## PLANNING REPORT

# Architectural Review Board

## 87 S. HIGH STREET 23-006INF

| Proposal                | Informal review and feedback for a rear addition and restoration of an existing two-story building in the Historic District.                      |

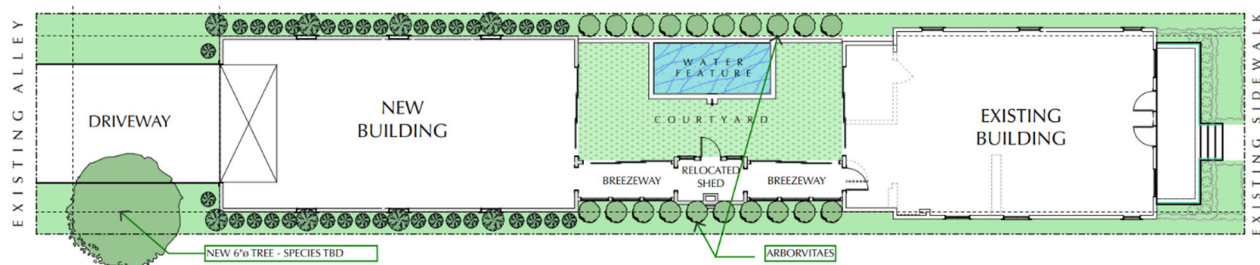
To accommodate the proposed development, the applicant is deconstructing the existing well house and proposes to reconstruct it within the new breezeway to highlight its historic influence. The Guidelines, Section 4.13, speaks to the importance of outbuildings and their goal

for preservation. The Board is asked to consider whether the deconstruction of the shed is appropriate and if a demolition permit will be required.

## Elevations

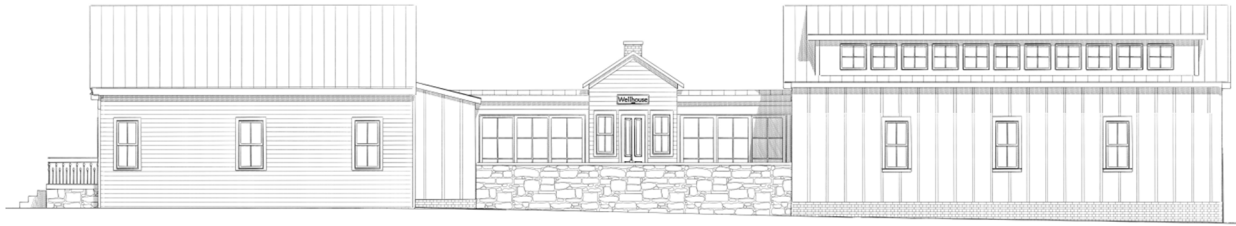
The historic east façade is to remain unchanged to preserve the pedestrian interaction on S. High Street. The windows would be replaced with the original muntin patterns, along with a new porch and new railing. There is a visual change in the elevation with the addition of the new construction and resulting visibility of the gable roof behind, as shown. The new roof pitch would be 3:12. The existing pitch is 8:12. As per Section 153.175 of Historic District Zoning Code, to reinforce the traditional development character of the district, a pitch between 6/12 and 12/12 is required unless otherwise architecturally appropriate by the ARB. A Waiver will be required to support the pitch of 3:12.

The north elevation contains two prominent sections, which forms the overall building, a front gable facing S. High Street (on the left) and a front gable facing Mill Lane. The rear facade of the existing building and the new construction is proposed as board and batten siding. The low stone masonry garden wall is shown in between the two buildings. The new breezeway with restored well house can be seen behind the garden wall. The first floor of the new construction has window openings in a similar grid to the existing structure, and the upper floor has series of dormer windows.

The south elevation is very similar to north elevation from the front and rear. Between the two buildings is the proposed breezeway, glass connector, and the relocated/restored well house. The well house's reconstructed red brick chimney is located in between.

The west elevation contains a two-car garage with traditional style doors and windows. A ganged double-hung window is proposed on this elevation, centered between the garage doors. The shed dormers on the north and the south sides of the rear addition are visible on this elevation.
